### WHITEMAN TUB REPLACEMENT

All Whiteman power buggy tubs and tub mount frames have been standardized, now featuring 30° corners. This production change took effect July 2020 to include replacement parts. The original tub (square corners) part #18004 was discontinued, replaced with new style tub (30° corners) part #808271.

Original Tub  
Square Corners, (Discontinued)

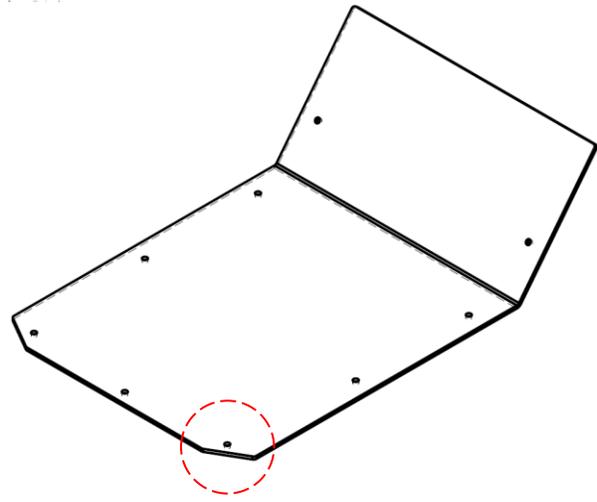
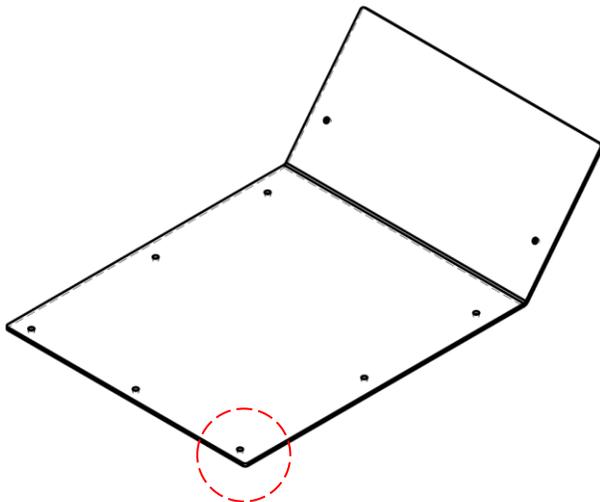
**Please Note:** When installing the new style tub with 30° corners on an older tub mount frame will require drilling two new mounting holes. It's not necessary to cut the original tub mount frame to match the tub corners unless desired.

1. Measure and mark the location of the new holes per the following specification at both corners and drill two new 3/8" holes
2. **Note:** It's not necessary to cut the tub mount frame corners unless desired. If desired, cut both corners off per the following specification
3. Two new Nyloc nuts 3/8"-16NC will be needed part #EM968013
4. Set and align tub on tub mount frame and drill new tub mounting holes
5. Secure tub with existing and new hardware
